May 17, 2011

**SUBJECT: SECOND RESPONSE TO APRIL 5, 2011 SELECTED COMMENTS
PROVIDED BY U.S. FOREST SERVICE REGARDING GROUNDWATER
FLOW MODELING CONDUCTED FOR THE ROSEMONT PROJECT**

Water Resource Consultants **FIGURE WS-1**

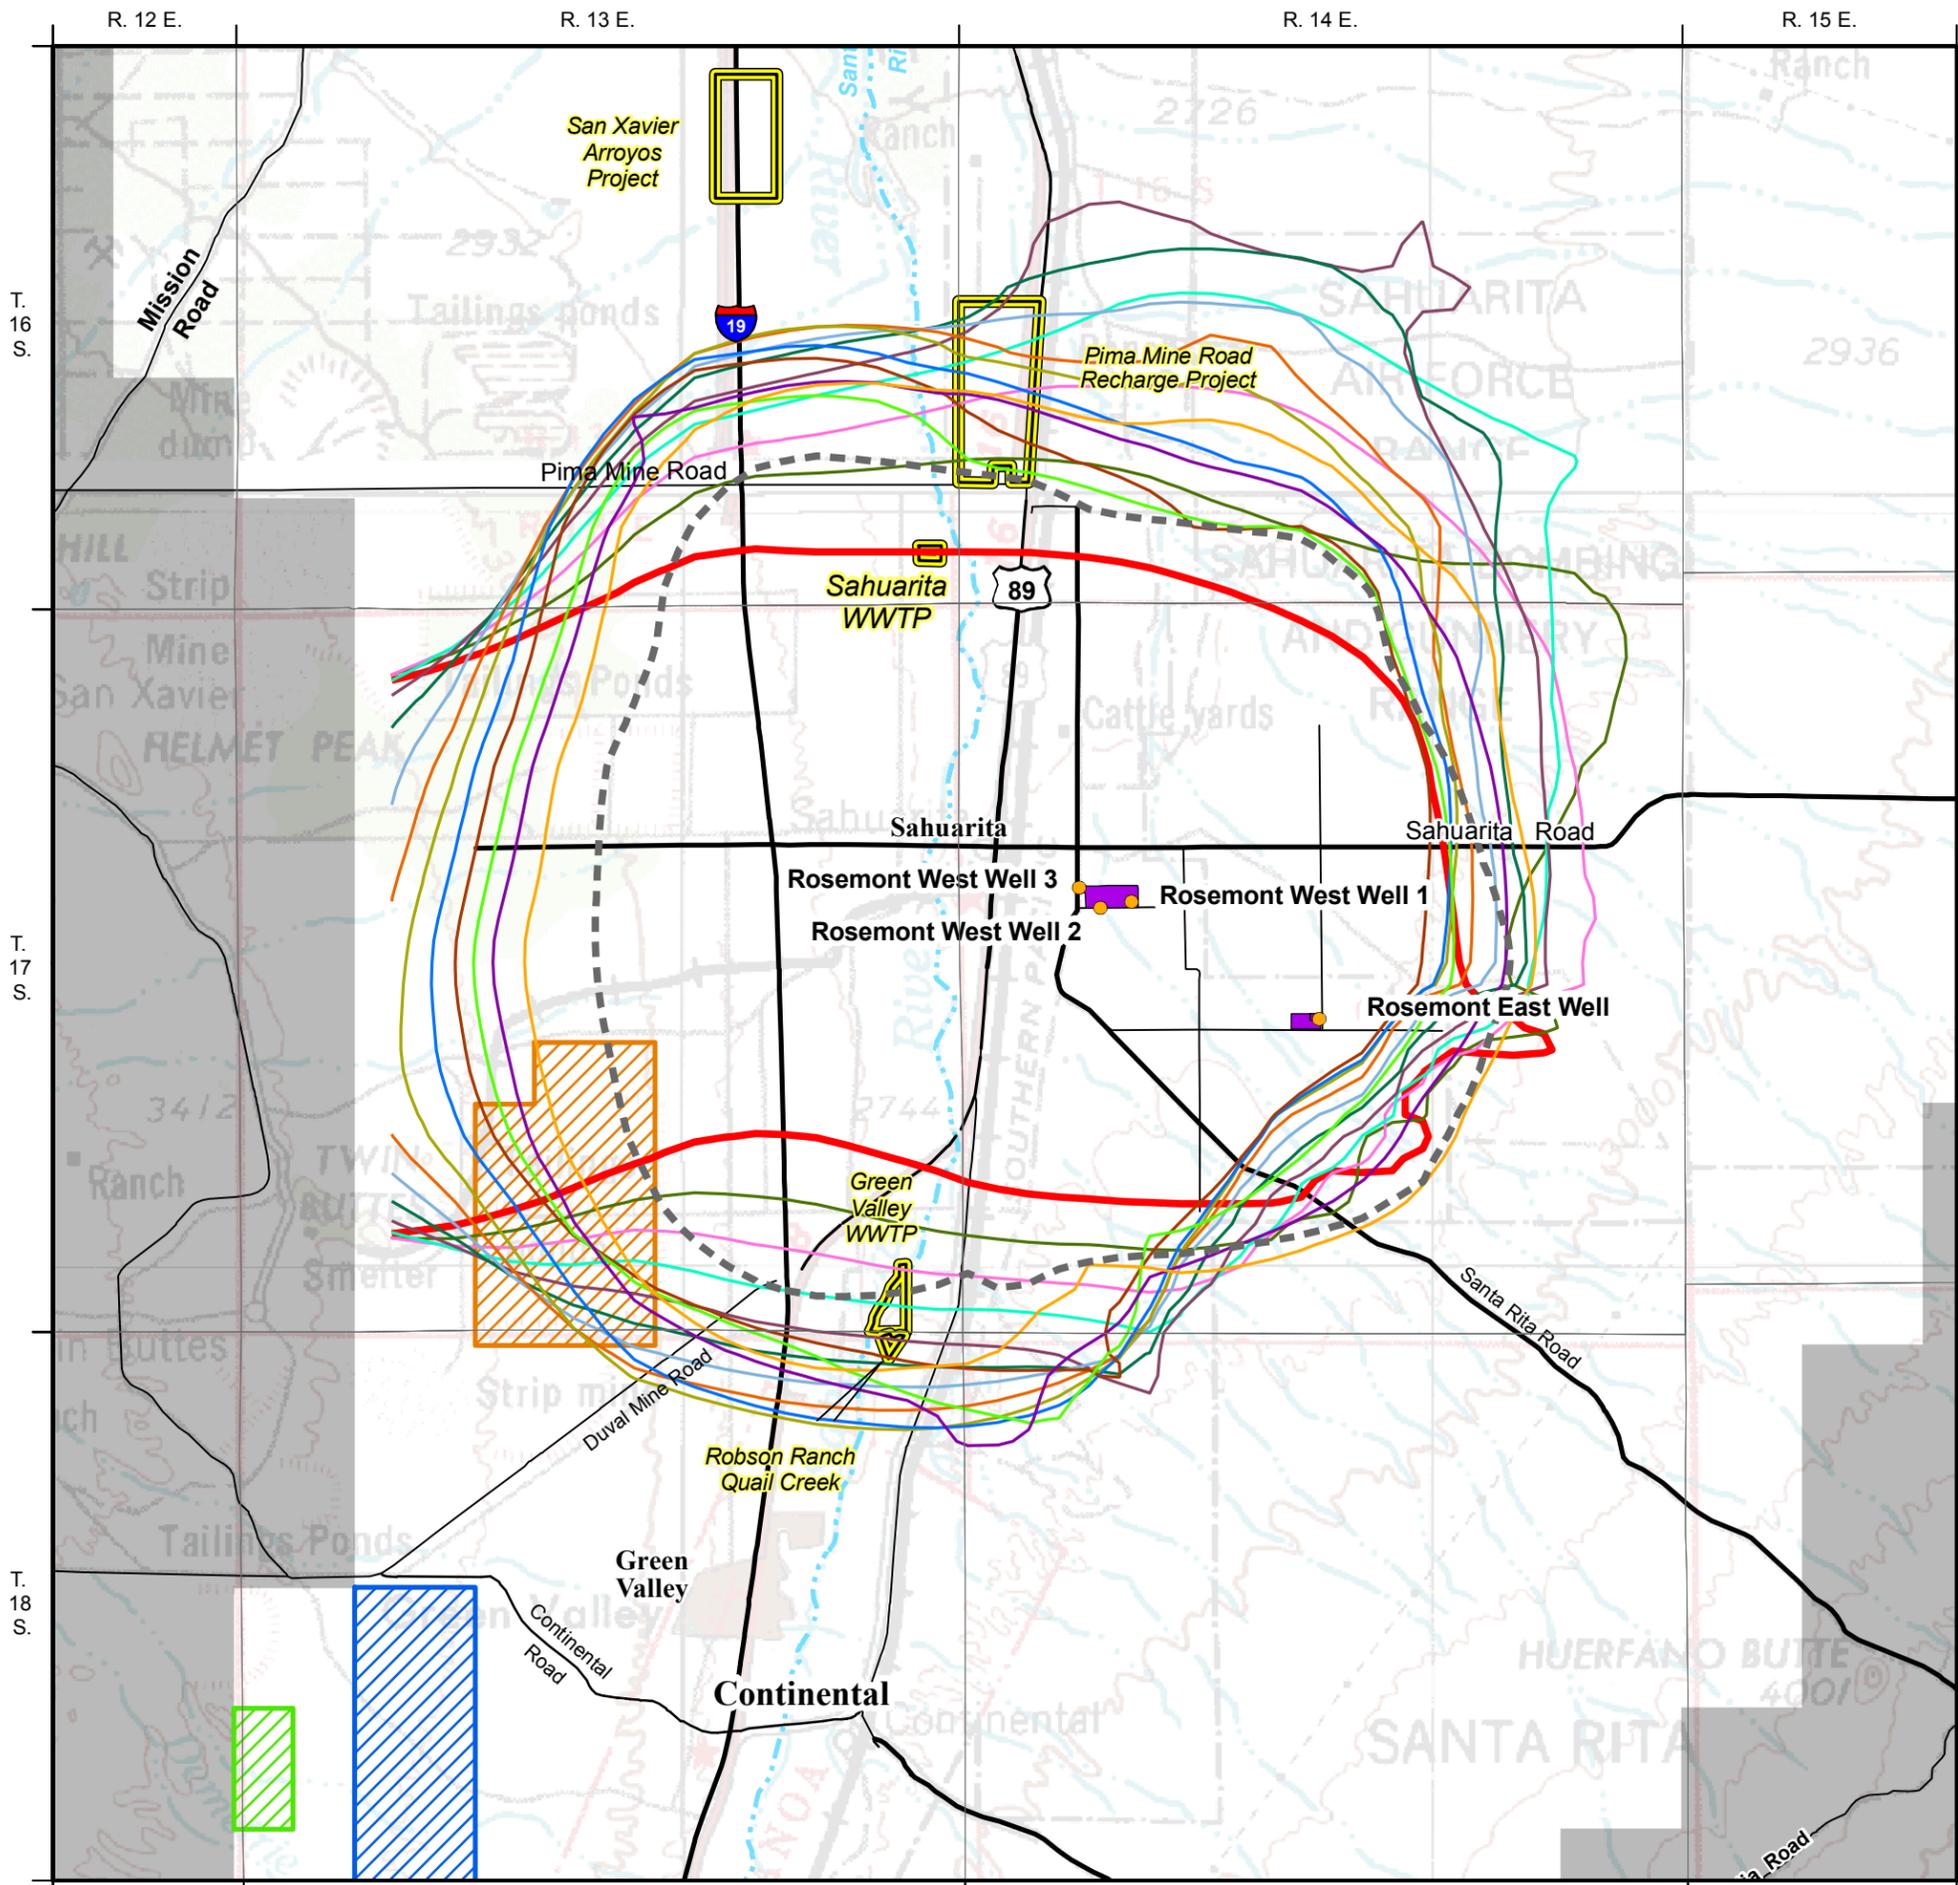
***FS/BLM Comment (WS-1):** Describe in detail why extending the model time frame after pumping cessation is not possible or warranted. Presently the model drawdown contours are temporally described only at the end of pumping. The 1 foot and 10 foot cone of depression contours could extend laterally further out for years, depending on aquifer parameters.*

M&A WS-1 Response: It is correct that residual drawdown will propagate outward after shutdown of the Rosemont wellfield; however, the groundwater levels will begin recovering immediately after shutdown in the vicinity of the Rosemont wellfield, which is the primary focus of the impact study for Rosemont pumping. For illustration purposes, the 10-foot projected drawdown contour from end of pumping through 140 years after pumping ends is shown for 10-year increments on **Figure WS-1**. Results indicate the 10-foot drawdown contour continues to propagate outward, reaching maximum extents in different directions during the 140-year post-pumping period.

Drawdown due to Rosemont pumping is determined by subtracting projected groundwater levels for the Rosemont pumping simulation from projected groundwater levels for a simulation without Rosemont pumping. Due to

declining regional groundwater levels in the Tucson Basin, extension of the model simulation into the future resulted in cessation of some regional layer 2 pumping due to dewatered model cells; in some cases these cells dewatered sooner in the Rosemont pumping simulation. To remedy this problem, starting in 2038 all pumping from layer 2 was moved to layer 3 for purposes of comparing with and without Rosemont pumping simulations to determine drawdown from Rosemont pumping only.

The 10-foot contour provides an obvious metric for the determination of drawdown impacts based on the Arizona Administrative Code's Well Spacing Rule R12-15-1302, which **specifies drawdown at a well adjacent to a new pumping well cannot exceed 10 feet within 5 years after the start of pumping. However, the Rosemont wells will be permitted as mineral extraction wells and are exempt from this well spacing requirement, and the 10-foot drawdown contours shown on Figure WS-1 are for as much as 160 years after start of pumping rather than 5 years.**
